# *Camden Residents' Action Group*

RE: DA 2019/225/1  
11 Mitchell Street Camden

Although it would appear that some of the issues have been addressed, we object to the revised proposal as it remains non-compliant with the LEP, DCP, UDF and Flood Policy in terms of its heritage impact and flood planning.

Source: J Mammone 15 January 2020 *Architecture Architectural Public Plans Issue K*

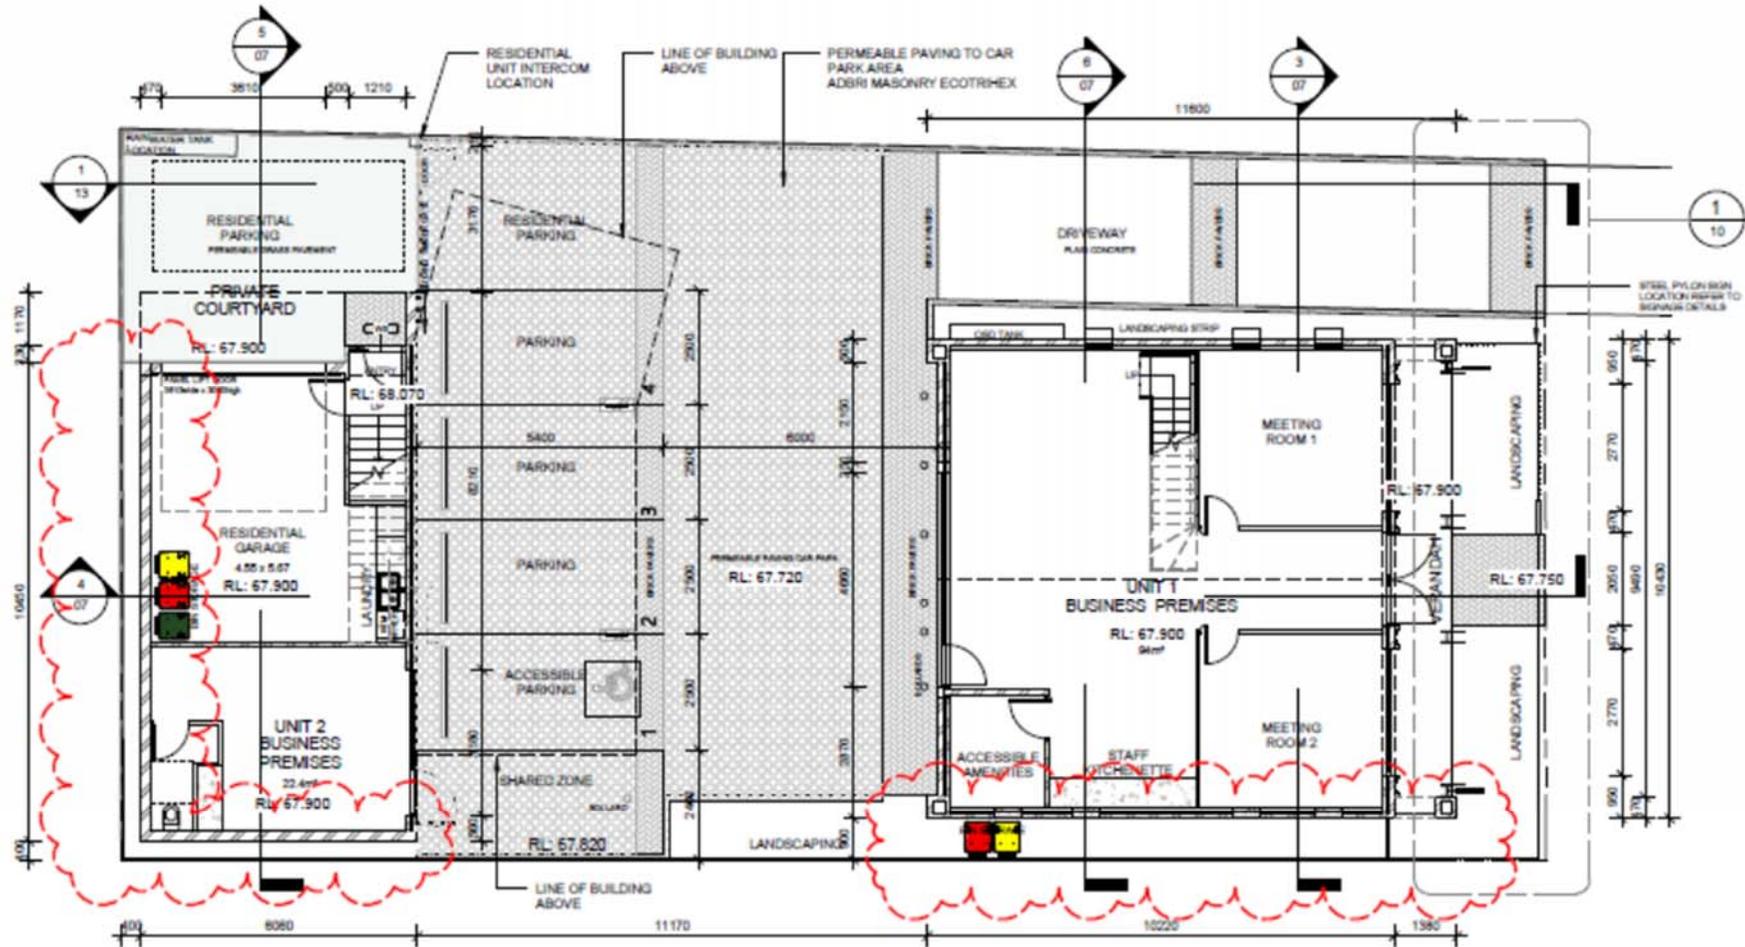
The inclusion of shop top housing in the plans creates an over-development and uncharacteristic crowding of the site as can be seen in the diagrams extracted from the documentation below. This

also raises questions about DCP (Part 4) residential controls generally and specifically compliance with those for shop top housing.

DCP (4.8, p. 195) covers shop-top housing and lists key controls including a rear setback of 6m, a side setback of 2m and site coverage not exceeding 50%, and a landscaped area of at least 30%. As the site area is 485.8m<sup>2</sup> the required landscaped area is a minimum of 145.7 m<sup>2</sup>.

Source: J Mammone 15 January 2020 *Architecture Architectural Public Plans Issue K Ground Floor Plan Sheet 4* extract

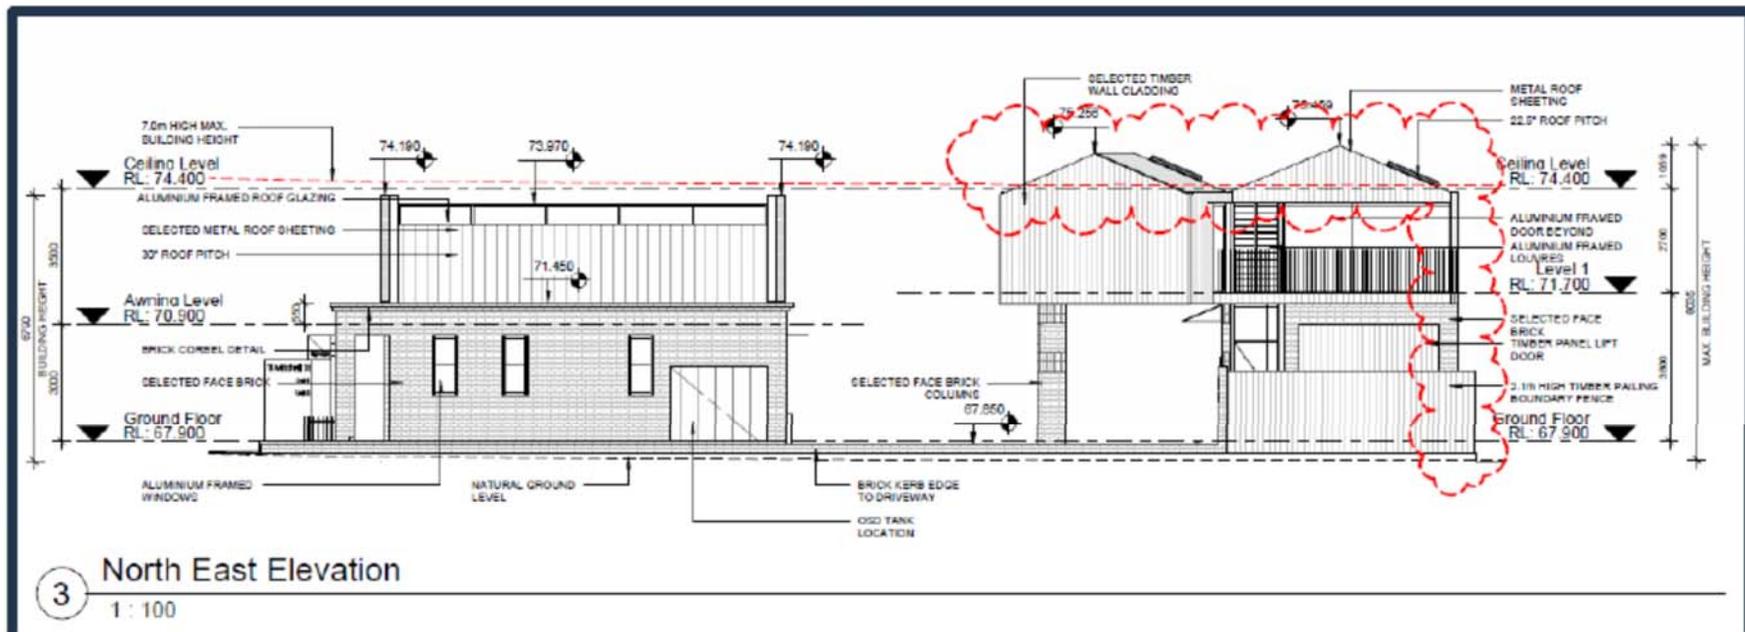
The artist's impression above and architectural plans below show minimal setbacks and minimal landscaped area, with most of the site taken up by building or hardstand.

Source: J Mammine 15 January 2020 *Architecture Architectural Public Plans Issue K*

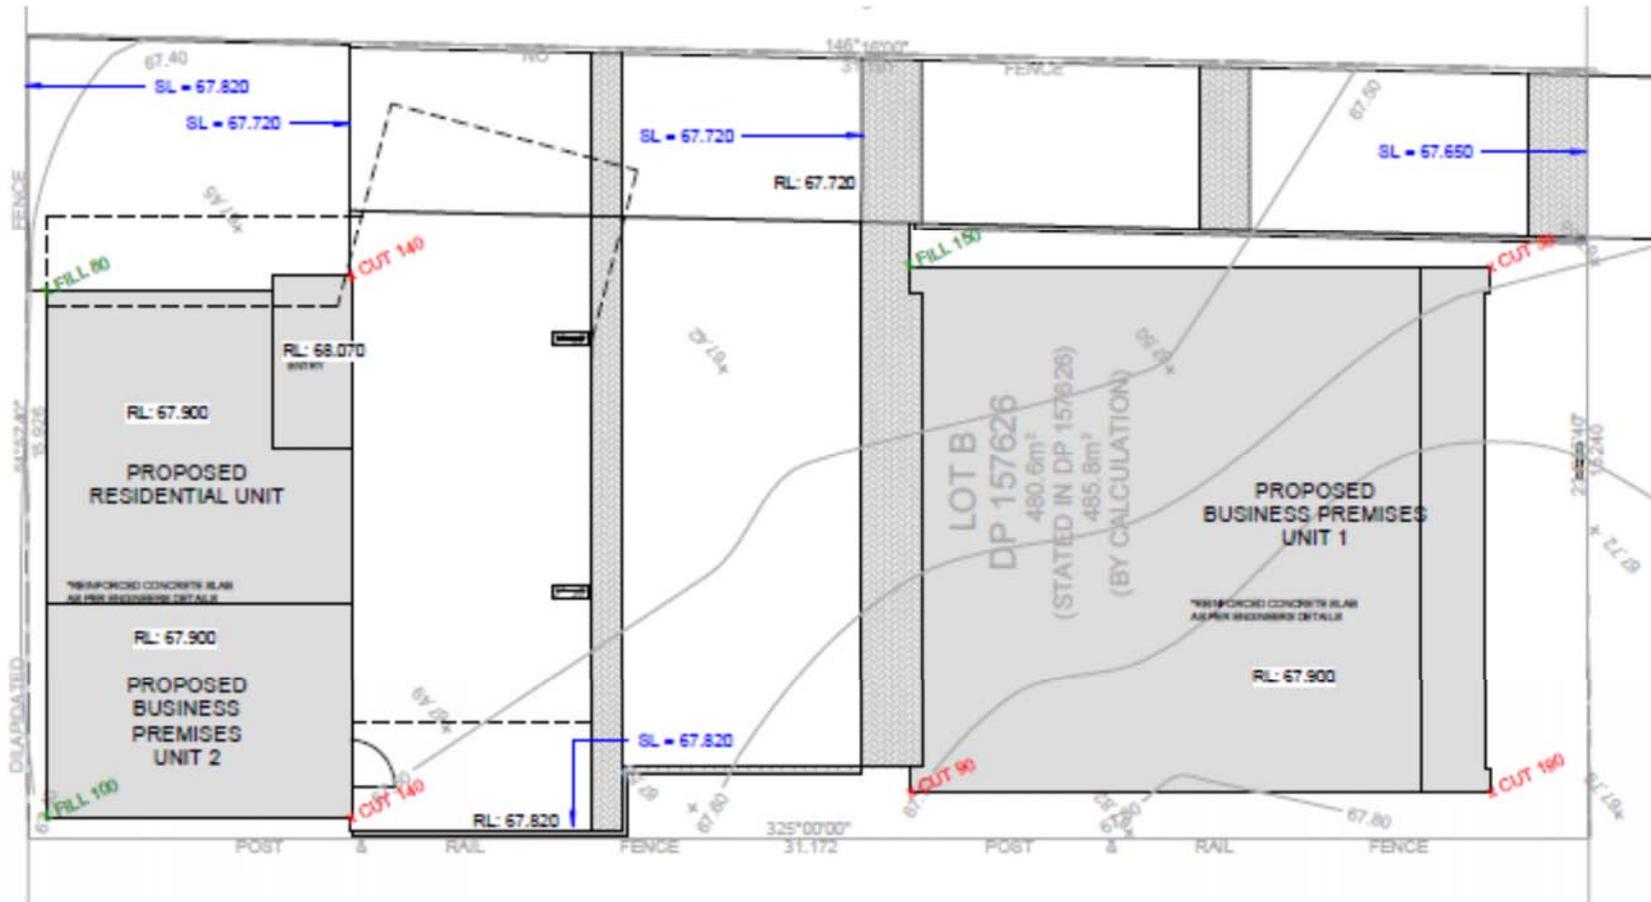
Although the Flood Report (p.4) states that there should be no filling or alterations to ground levels onsite the Architectural Plans, as shown in the extract below, clearly show a Cut and Fill Diagram. As referred to above, fill operations are not be permitted in flood storage areas according to the Flood Policy (Para 2.5 Land forming and fill operations). The DA documents do not address the possibility of adverse impacts of the cut and fill on flood behaviour and the environment.
